MANUAL IDENTIFICATION

Model Number: 8690B
Date Printed: May 1972
Part Number: 08690-90018

This supplement contains important information for correcting manual errors and for adapting the manual to instruments containing improvements made after the printing of the manual.

P/O Figure 7-3. Frequency Control Section Reciprocal Amplifier

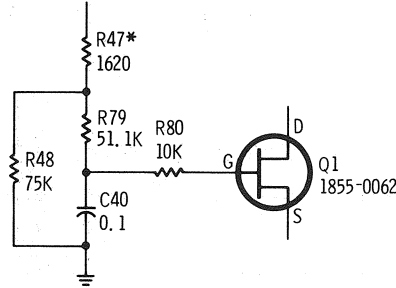
▶ Change the circuitry of A3Q1 as shown in the attached drawing:

Component Identification, Assembly A9

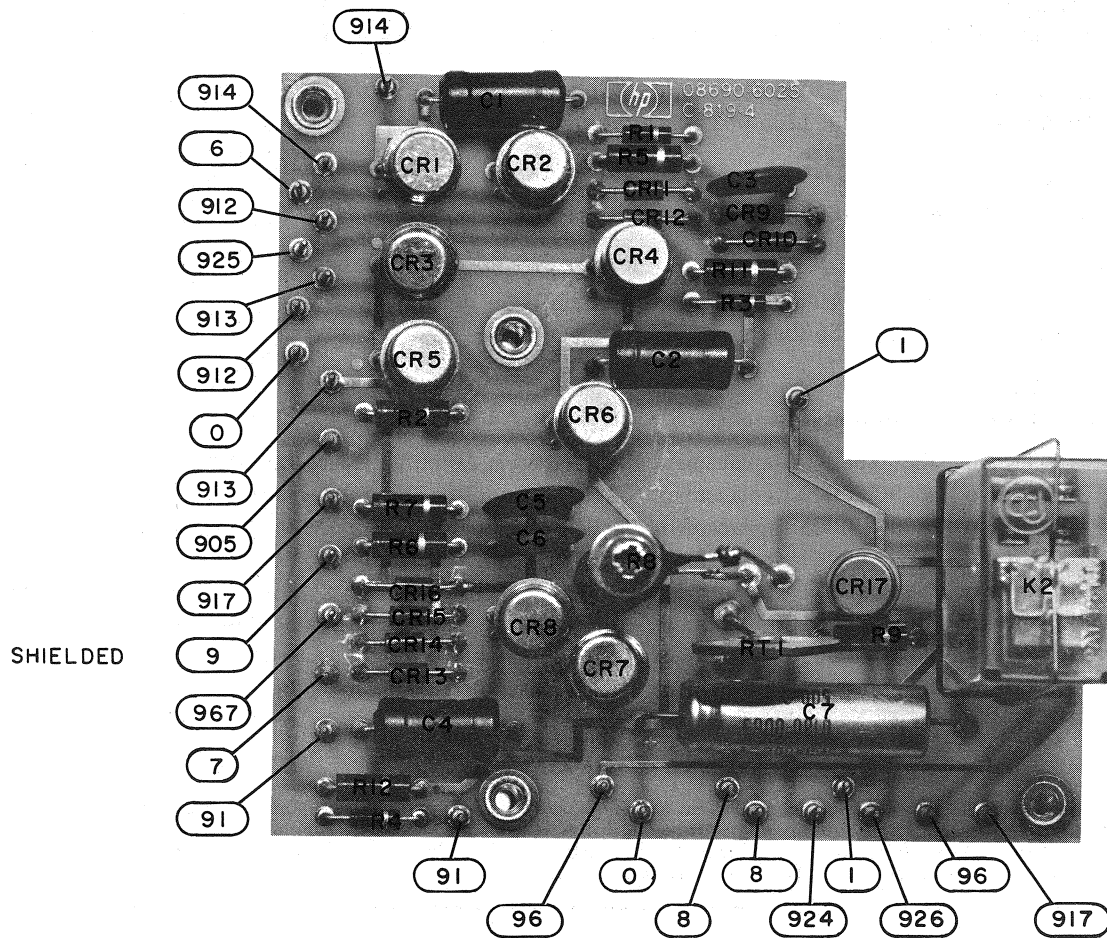
▶ Page 7-14 and 7-16, Component Identification, Assembly A9:

Substitute the attached A9 Component Identification board for that shown in the 8690B Manual.

Figure 1. Component Identification, Assembly A8 (Part of Change 1)

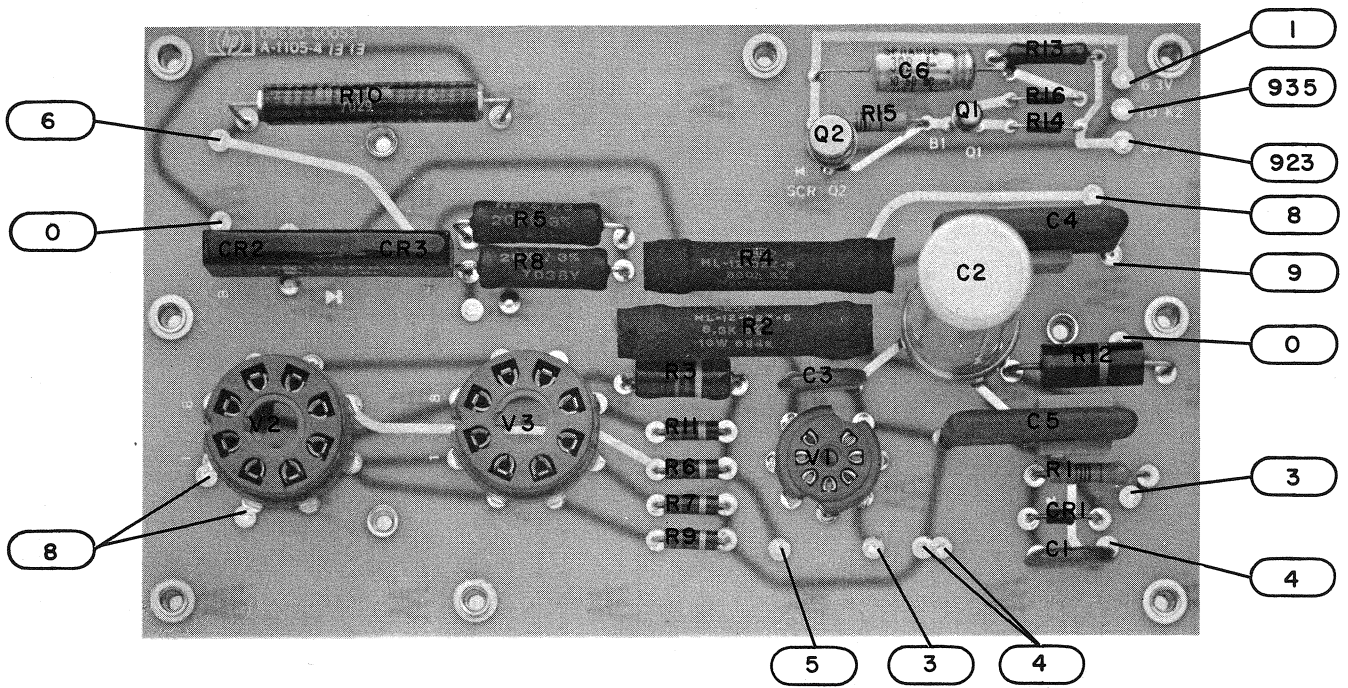
Page 7-14:

Substitute the attached A8 Assy, Component Identification board photo (Figure 1) for the photo shown in the 8690B Manual.

Figure 2. Component Identification, Assembly A14 (Part of Change 2)

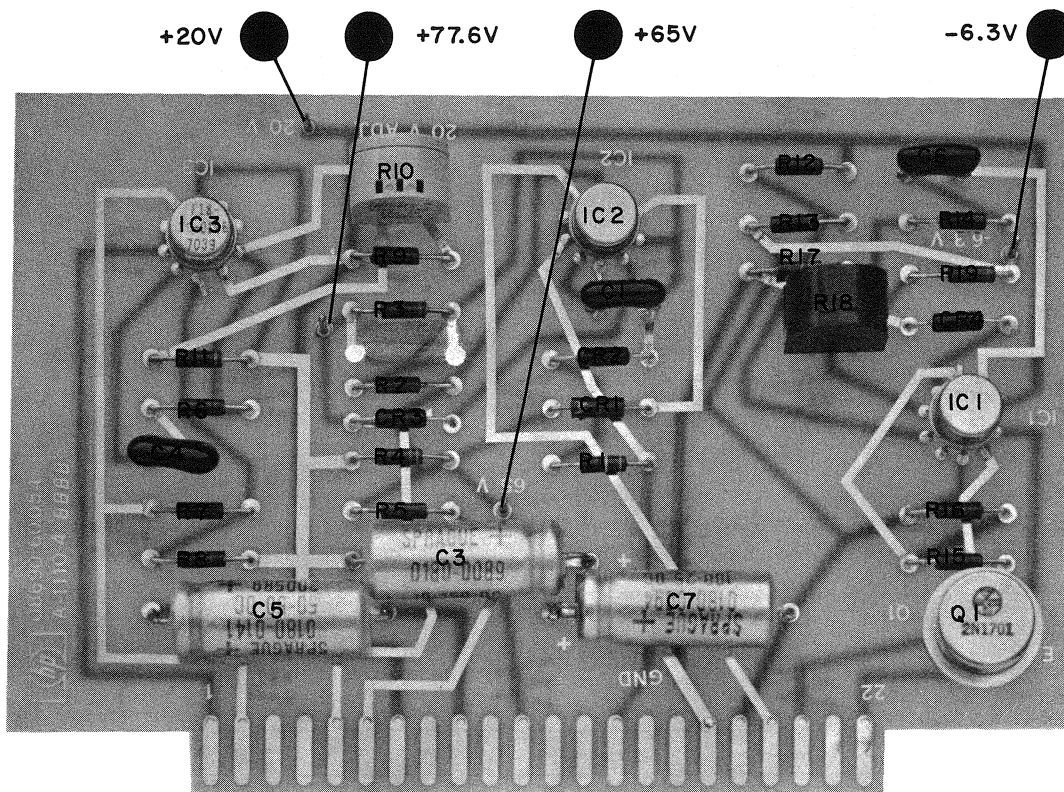
Page 7-14/7-15, Component Identification photo and Figure 7-8:

Substitute the attached A14 Assy board photo and schematic (Figures 2 and 3) for those shown in the 8690B Manual.

Figure 4. Component Identification, Assembly A4 (Part of Change 5)

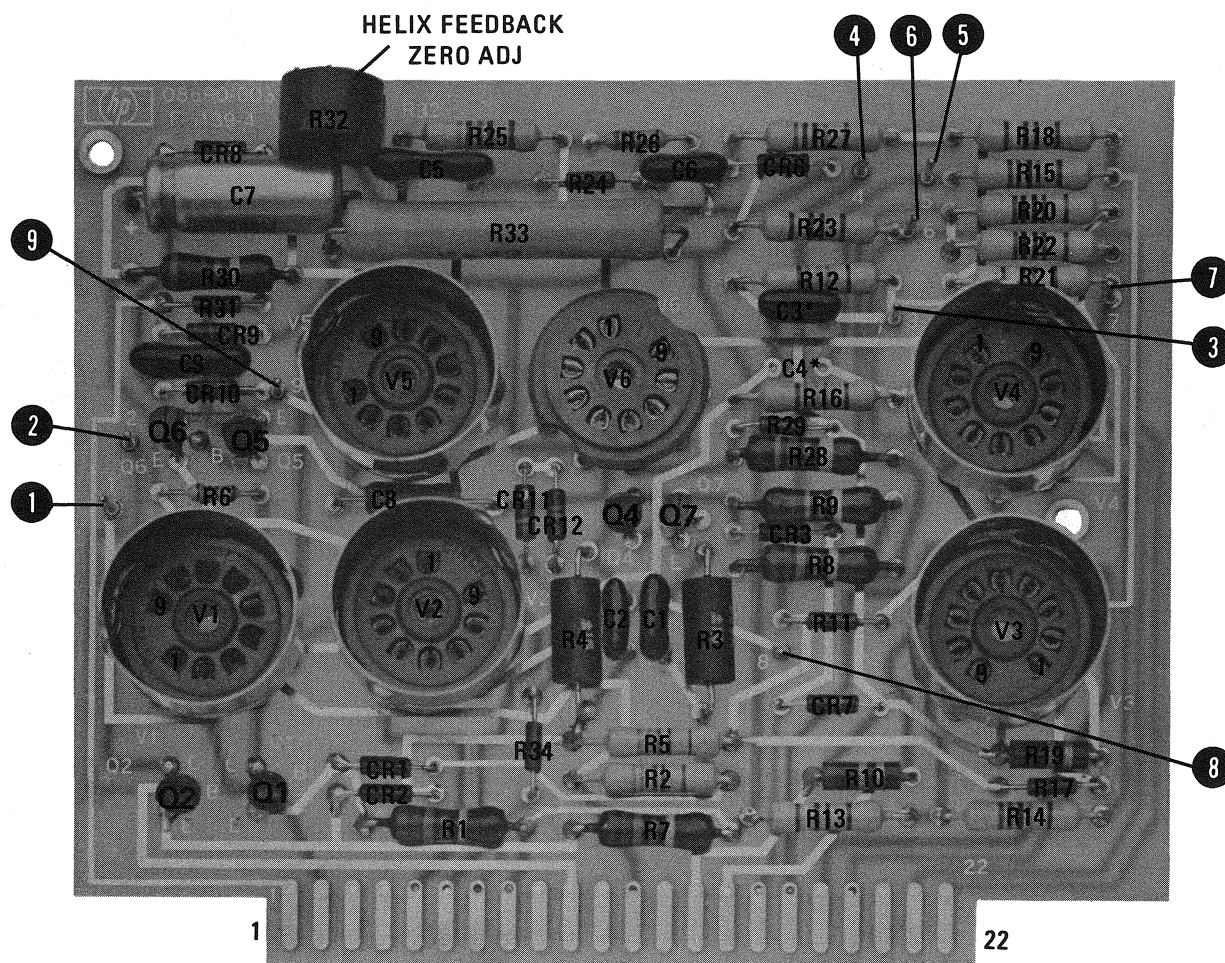
Page 7-9, Figure 7-5:

Add diode A4CR12 in series with zener diode A4CR11. Connect cathode of A4CR12 to ground, and anode to A4CR11.

Figure 5. Component Identification, Assembly A3 (Part of Change 1)

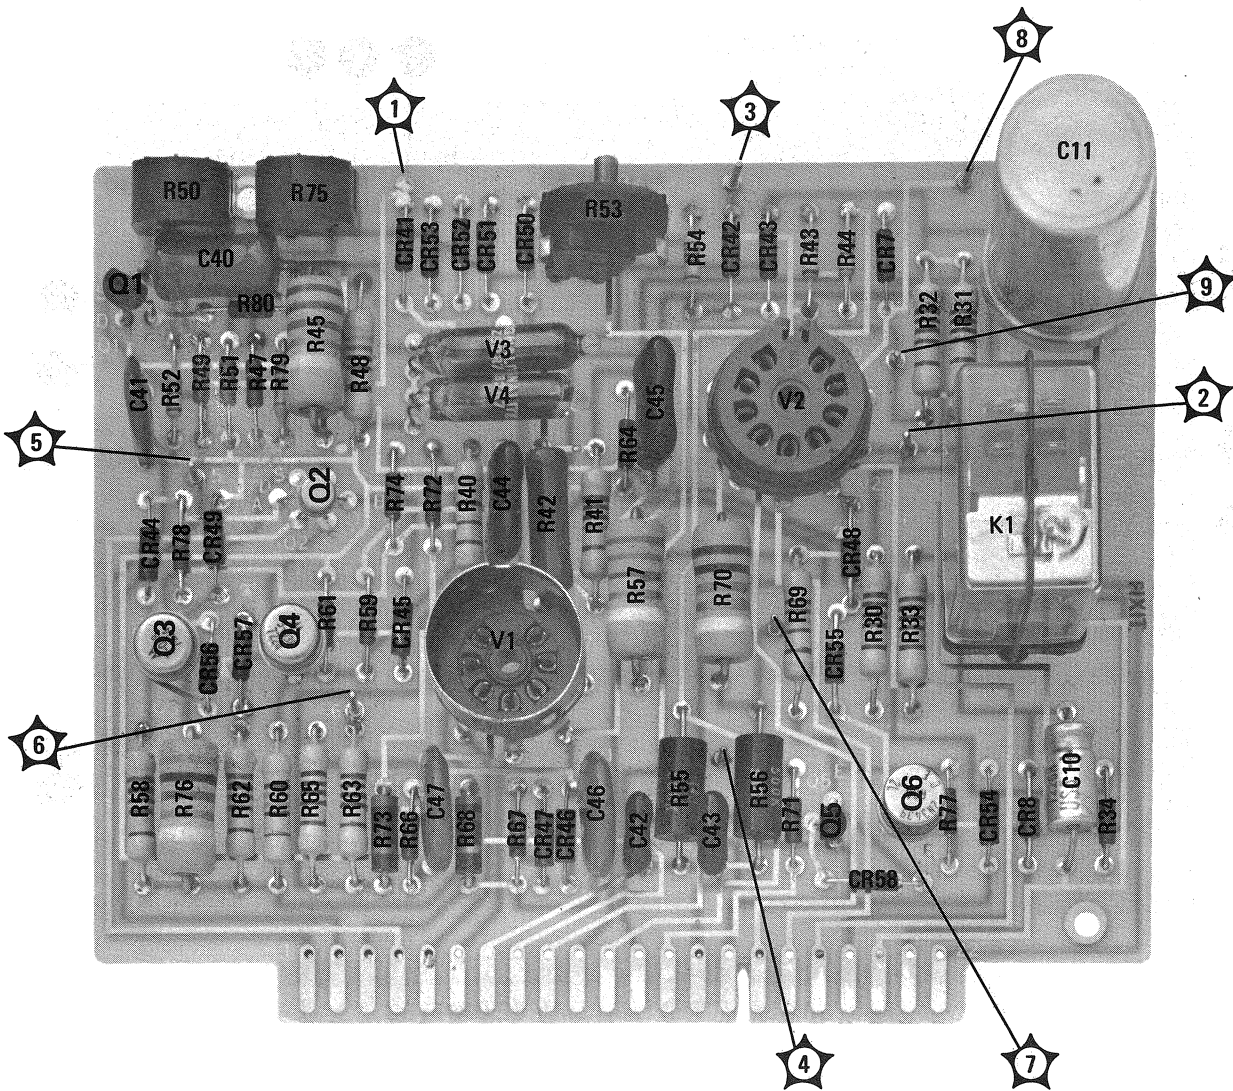
Substitute the attached Component Identification Assembly A3 board photo (Figure 5) for the photo shown in the manual.
